SUZUKI 2-Stroke Service Bulletin

Subject: GT SERIES SPARK PLUG CAPS

Bulletin No: GT-27
Date: Nov. 14, 1975

Subject: GT550 & GT750 SECOND DRIVE &
DRIVEN GEARS

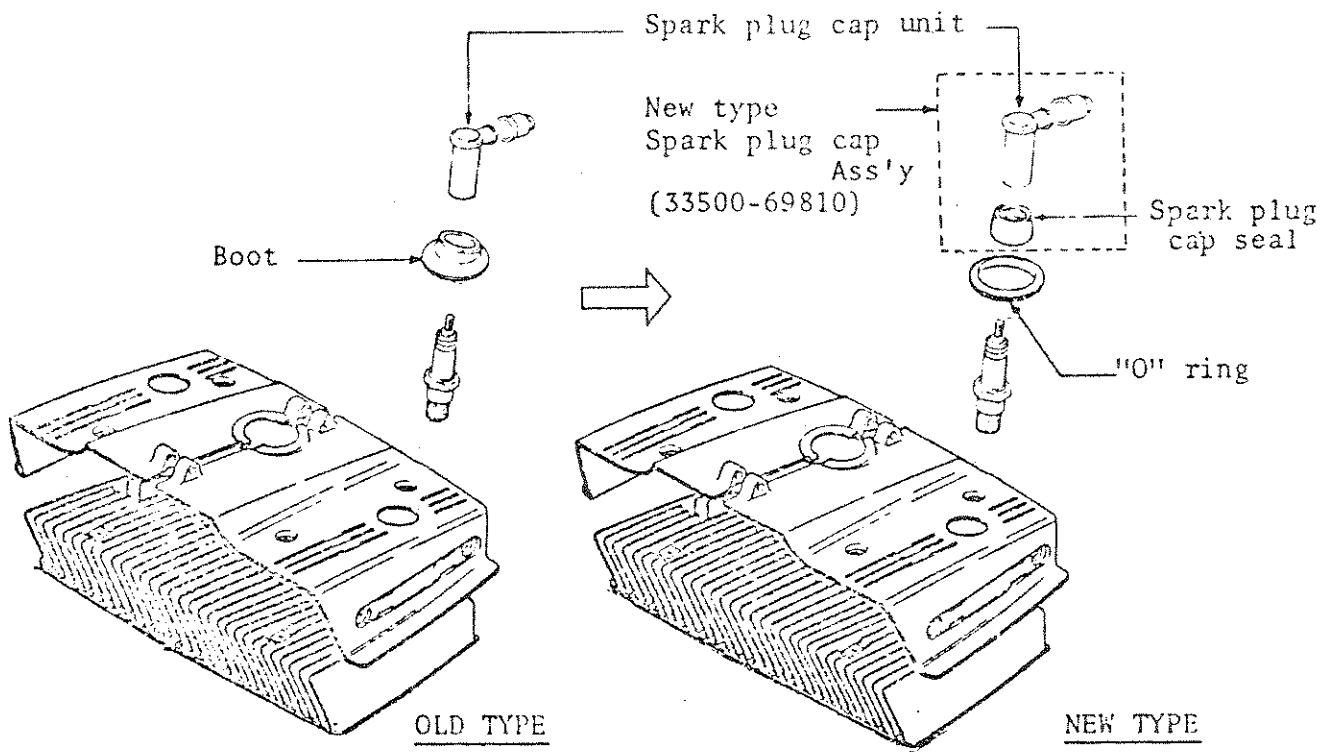
Use of the rubber spark plug cap boot on the GT ram air covers has been discontinued. To take the place of the boot, a spark plug cap seal (also used for other models) and a rubber 'O' ring are now used as shown below.

Whenever a GT model equipped with spark plug cap boots is misfiring, inspect the inside of the spark plug cap unit for "tracking". If it is tracking, replace the spark plug caps and discard the boots, replacing them with the new 'O' rings.

Subject: 1976 GT250 IGNITION TIMING MARKS

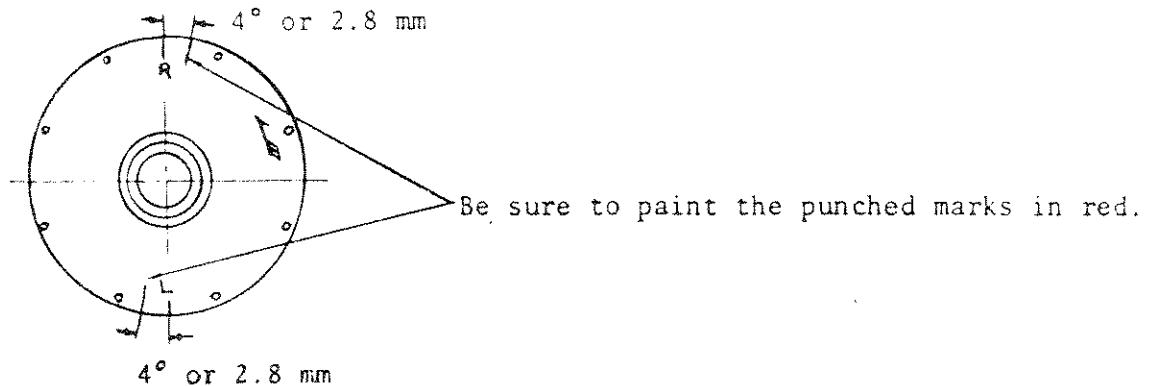
In conjunction with other engine design changes, the ignition timing for the 1976 GT250 has been retarded 4° from the 1975 specification of 24° (2.88mm) to 20° (2.05mm).

In order to have the timing marks on the rotor align with the stationary mark on the crankcase, it is intended to relocate the crankshaft's rotor keyway. However, some initial 1976 production units are equipped with crankshafts without the keyway being relocated. Therefore, another timing mark has been stamped on the rotor and is distinguished by red paint.

Should it become necessary to replace a rotor on an affected 1976 GT250 (Frame Nos. 80001-83000), be sure to punch the 20° timing marks as illustrated.

I. Cylinder

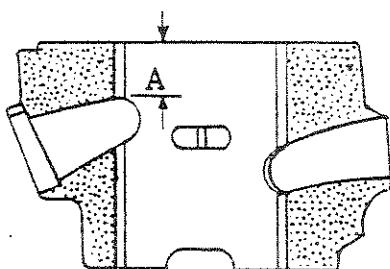
- a. The cylinders exhaust port has been raised 2.5mm for increased performance.

A: 32mm → 29.5mm

III. Piston

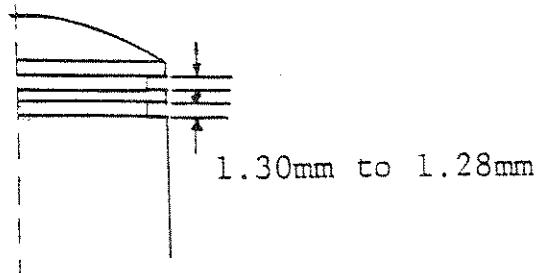
- a. In conjunction with cylinder port modifications, the piston ring locating pin positions have been changed.

b. For improved piston ring gas sealing, the piston ring groove height has been narrowed from 1.30 to 1.28mm.

IX. Transmission

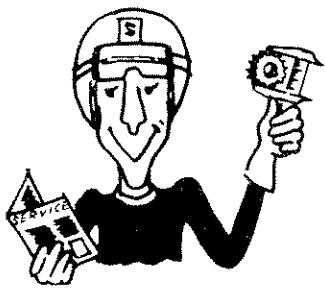
Third driven gear retains the same number of teeth (22), however the gears profile has been changed to match the new 3rd drive gears,

I. Rear Brake Shoe

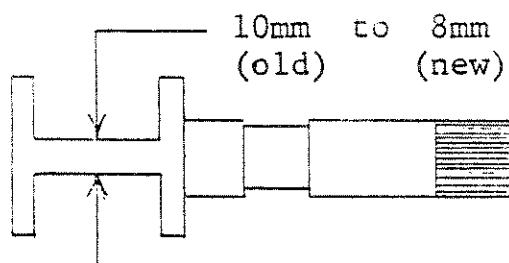
The width has been increased from 28mm to 33mm.

The thickness of the brake cam has been decreased from 10mm to 8mm as shown.

III. Rear Brake Cam Lever

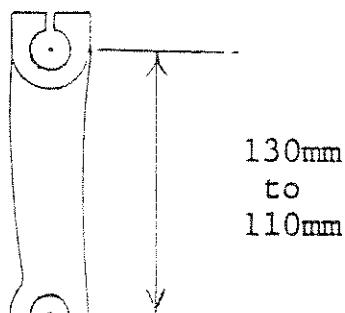
The overall length of the cam lever has been increased from 110mm to 130mm, for more leverage.

IV. Rear Brake Panel

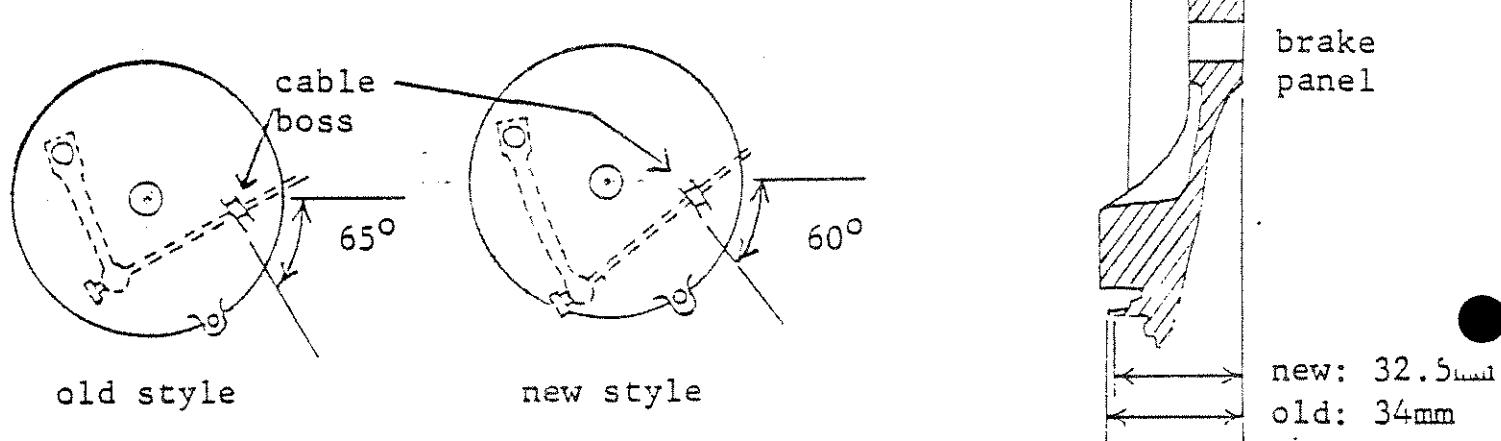
In compliance with changes I, II, III, the rear brake panel (brake backing plate) has undergone two changes: the first change is the angle of the cable boss in conjunction with the increased length of the cam lever. Secondly, at the same time the width of the panel has been decreased 1.5mm, as shown.
